Technical Note: Testing the effect of different pump rates on pore-water sampling for ions, stable isotopes and gas concentrations in the hyporheic zone

Below, we have provided a detailed point-by-point list of answers and replies to the comments and suggestions raised by the reviewer. We have made every attempt to address the excellent suggestions and the numerous valuable recommendations where appropriate and have provided detailed responses and explanations below.

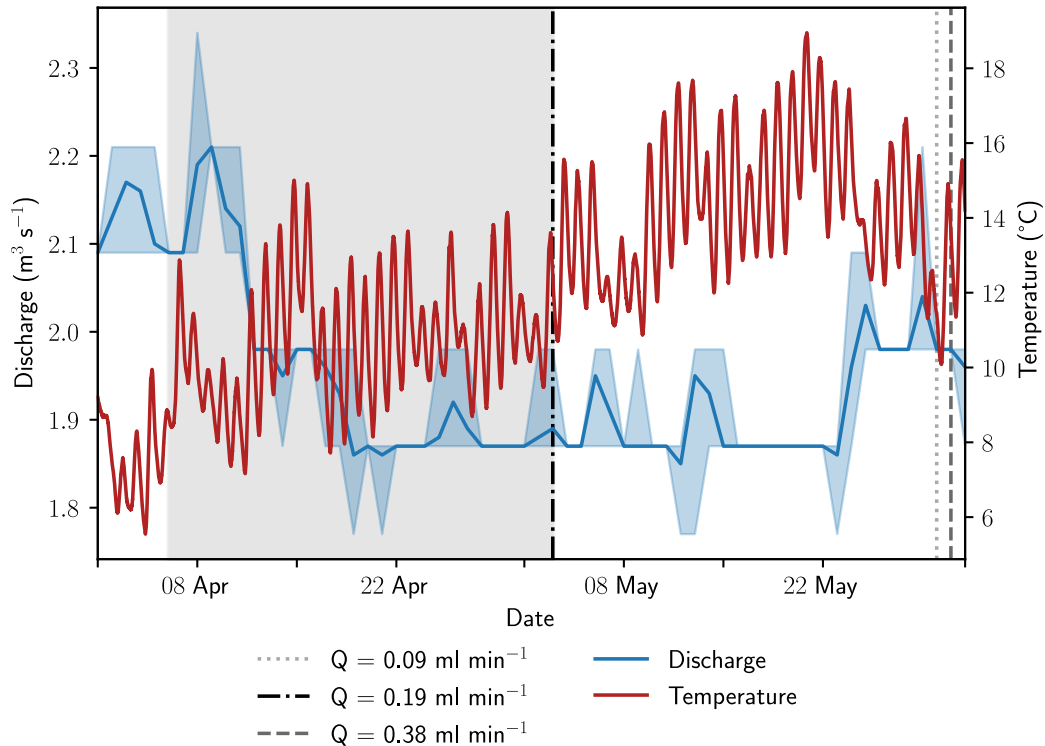
Finally, I think it could be very useful to add at least a hydrograph and a timeseries of the water or sediment temperature for the experimental period. This would facilitate the comparison (and the interpretation) of the three sampling days.

From the provided temperature time series, it is impossible to assess the stream and/or pore-water temperatures prior and during the sampling days. In addition, the authors do not provide information about the discharge conditions during the experimental period. It is therefore not possible to evaluate, whether the hydro-climatological conditions were similar for the three sampling dates. As mentioned above, I would therefore suggest to provide this information.

Thank you for this good suggestion. We added the Figure below as Fig. 2 to the methods section. It shows stream temperature and discharge at a monitoring station approximately 5 km downstream of the sampling site. Discharge data was retrieved from the Bavarian State Office of the Environment (2023).

Added as Fig. 2.
